Variance Number: 11 110

RE: **Exchange Hall
2 School Street
Acton**

**ACCESSIBILITY REVIEW
EXCHANGE HALL
2 SCHOOL STREET
ACTON, MA 01720**

Applicable Code: 521 CMR Architectural Access Board Rules and Regulations

Photo No. 1

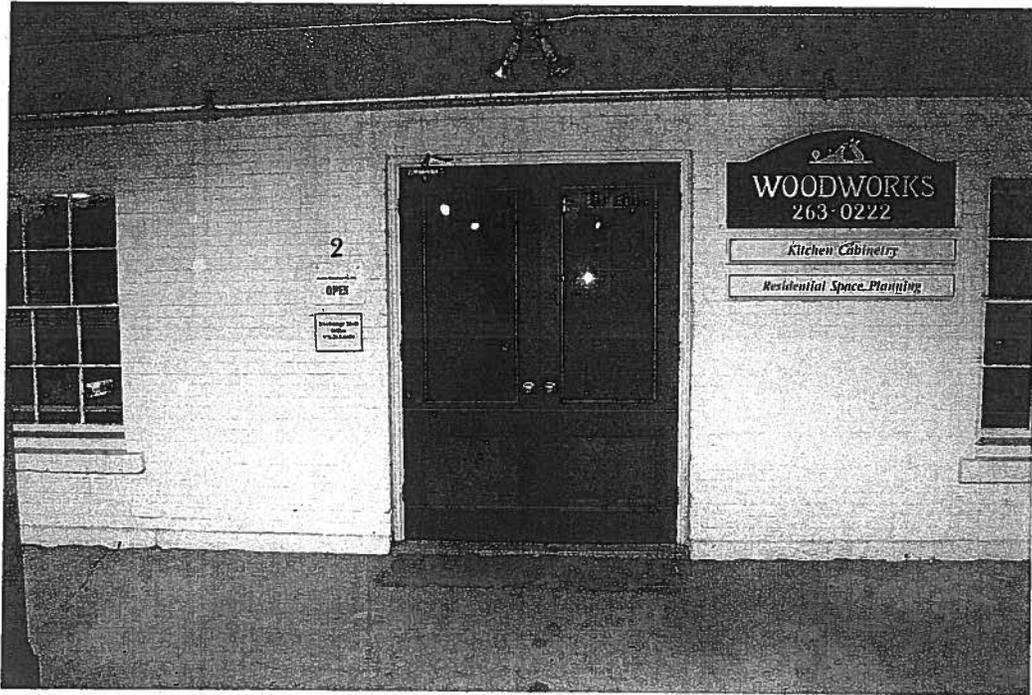
- A. Entrance/exit at door number 001, leading to an accessible route, does not comply with Section 29.2 LEVEL CHANGES. There is a 1 1/2" drop from the door threshold to the concrete walkway immediately outside of the entrance/exit. To be brought into compliance with 29.2, the walkway immediately outside the entrance shall have a change in level no greater than 1/2", with a 1:2 beveled edge, which requires the walkway to be raised approximately 1" with no more than a 2% slope for a distance of 60" from the face of the building (See Photo No. 1).

- B. Entry door number 001 does not comply with Section 26.00 DOORS AND DOORWAYS. Unit is an original 5'-0" double door unit with manual type flush-bolts and door knobs, and a coordinating original double storm door unit with manual type flush-bolts and door knobs. Neither of the door units comply with Sections 26.4, 26.5 and 26.11. The set of doors does not comply with Section 26.7 (See Photo Nos. 1 & 2).

- A. Entrance/exit at door number 001, leading to an accessible route, does not comply with Section 29.2 LEVEL CHANGES. There is a 1 1/2" drop from the door threshold to the concrete walkway immediately outside of the entrance/exit. To be brought into compliance with 29.2, the walkway immediately outside the entrance shall have a change in level no greater than 1/2", with a 1:2 beveled edge, which requires the walkway to be raised approximately 1" with no more than a 2% slope for a distance of 60" from the face of the building (See Photo No. 1). *Owner requests a variance to provide a tapered 6" wide hardwood threshold beveled to a 1:4 (25%) slope immediately outside the door in lieu of raising the entire walkway. The walkway is concrete, which means to properly raise the slope from 1 1/2" down to 0", the walkway would need to be completely cut and removed and new concrete installed. The Owner asserts that bringing this entrance into full compliance with 521 CMR is impracticable as it would result in excessive and unreasonable costs without a substantially more beneficial result than the above proposed alternate.*

Photo No. 3

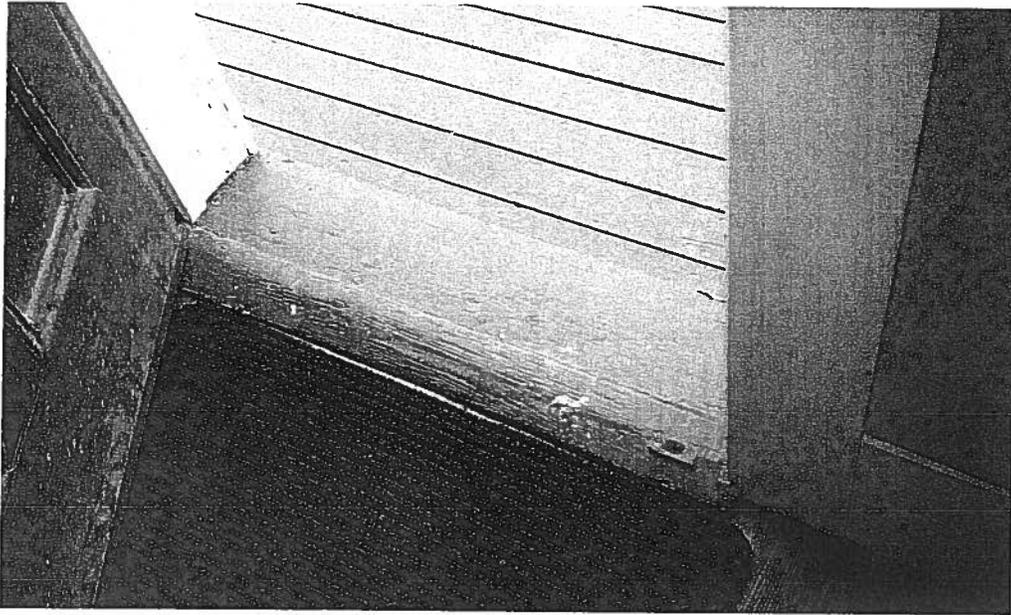
- A. Entrance at door number 107, leading to an accessible route., does not comply with Section 29.2 LEVEL CHANGES. There is a 1 1/4" drop from the door threshold to the floor immediately inside the entrance/exit (See Photo No. 3).

- A. Entrance at door number 107, leading to an accessible route., does not comply with Section 29.2 LEVEL CHANGES. There is a 1 1/4" drop from the door threshold to the floor immediately inside the entrance/exit (See Photo No. 3). *The Owner requests a variance for full compliance with 521 CMR, as the accessible route immediately outside the entrance/exit is a compliant 1/4" threshold. The Owner proposes to provide a tapered 5" wide hardwood threshold beveled to a 1:4 (25%) slope immediately inside the door. The Owner asserts that bringing this entrance into full compliance with 521 CMR is impracticable as it would result in excessive and unreasonable costs without a substantially more beneficial result than the above proposed alternate.*

Photo No. 6

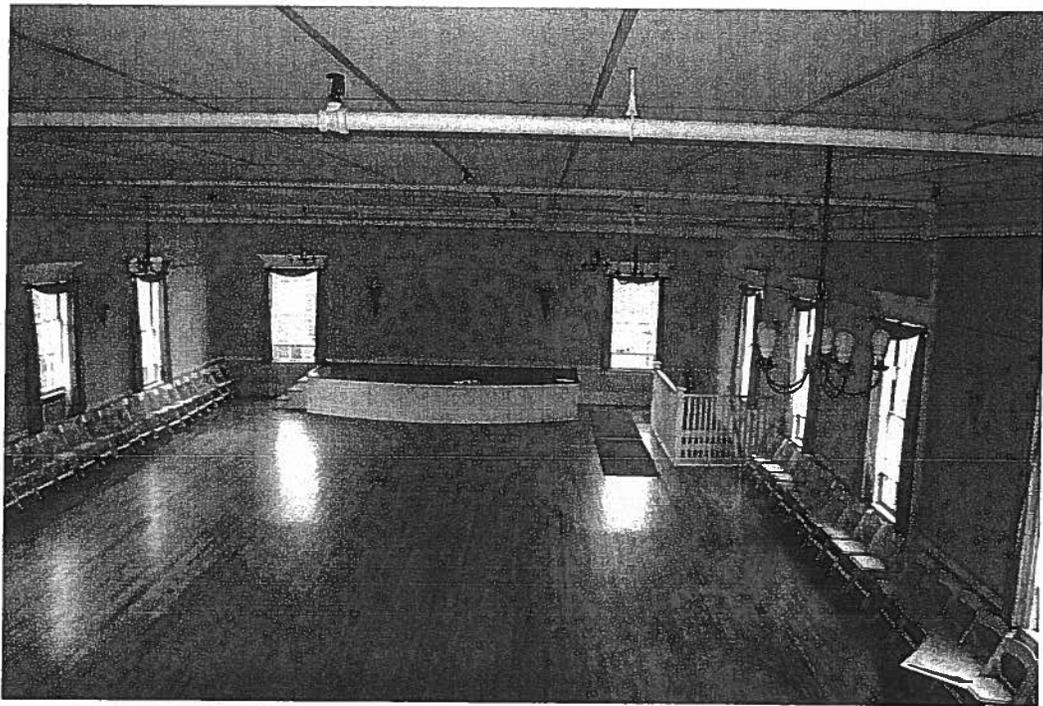
- A. The stage is approximately 2'-8" above the finish floor, which does not comply with Section 14.6 ACCESS TO PERFORMING AREAS. (See Photo No. 6)
- B. The toilet room on the west side of the building does not comply with Section 30.00 PUBLIC TOILET ROOMS. Door number 305 leading into the room has a clear opening of 2'-6 1/4", which does not comply with Section 26.00 DOORS AND DOORWAYS. The water closet is in a stall which is less than 3'-0" wide, which does not comply with Section 30.6 TOILET STALLS (See Photo No. 7). The water closet does not comply with Section 30.7 WATER CLOSETS. The sink does not comply with Section 30.9 SINK (See Photo No. 8). There are no grab bars, which does not comply with Section 30.8 GRAB BARS.

- *DENY* the variance requested for 521 CMR 14.6, regarding the lack of access to the stage at the third floor ballroom; based on the fact that the Board felt as though the Petitioner had not proven that the cost of full compliance would be excessive cost without substantial benefit to persons with disabilities. Therefore, the item in question must be brought into compliance with the applicable sections of 521 CMR.

Photo No. 9

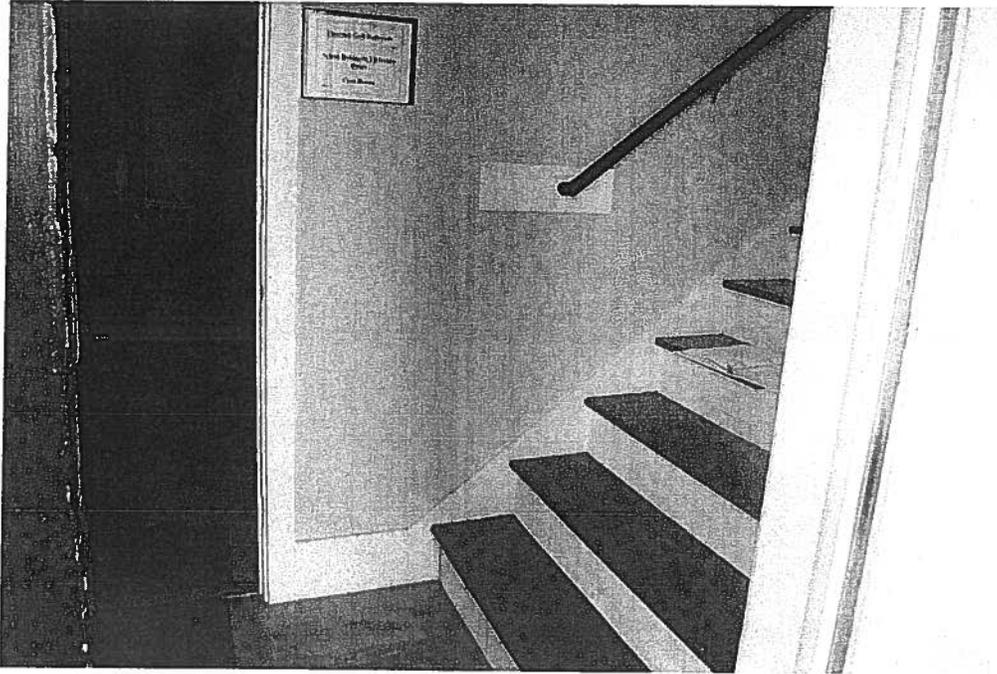
- i. Nosings are traditional bullnose with scotia molding below, which do not comply with Section 27.3 NOSINGS, requiring sloped risers or angled nosings with angle no less than 60 degrees from the horizontal.
- ii. Handrails do not comply with Section 27.4 HANDRAILS. Handrail on East side of stair is approximately 2'-8 1/2" above the stair nosings, which does not comply with Section 27.4.2. Handrails on both sides do not extend at the bottom of the stair run as far as space permits, which does not comply with Section 27.4.3 Extensions. Handrail on West side does not extend beyond the top riser, parallel to floor, which does not comply with Section 27.4.3 Extensions. Handrails on both sides have zero clearance from the floor edge and other trim projections, which does not comply with Section 27.4.7 Clearance (See Photo Nos. 9 & 10).

Section 27.4.7 Clearance (See Photo No. 9). *The Owner requests a variance for compliance with Section 27.4 for the handrails at this stair. The Owner asserts that the handrails at this stair are original historic handrails and that the modifications necessary to achieve full compliance are impracticable as they would result in excessive and unreasonable costs without a substantial benefit to persons with disabilities.*

Door 001 #P5

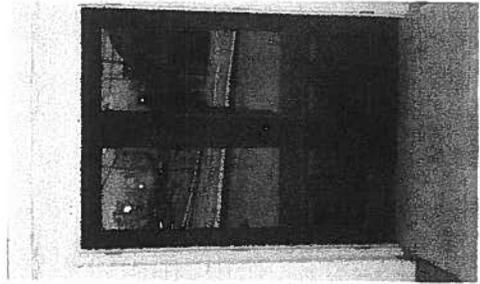
- Door 001: The requirements of 26.4, 26.5, 26.11 and 29.2 have been met. The doors were reworked to gain the proper clearance to the active door (photo #P5), with proper hardware 26.11 (photo #P5). A concrete ramp has been installed to correct 29.2 (photo #P4).

Door 001 #P5

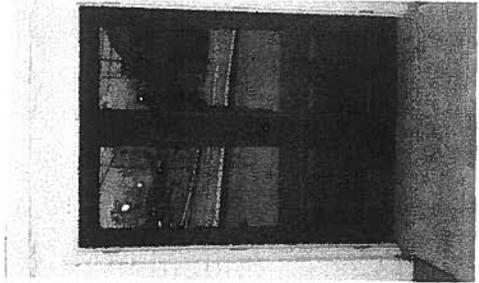
- Door 001: The requirements of 26.4, 26.5, 26.11 and 29.2 have been met. The doors were reworked to gain the proper clearance to the active door (photo #P5), with proper hardware 26.11 (photo #P5). A concrete ramp has been installed to correct 29.2 (photo #P4).
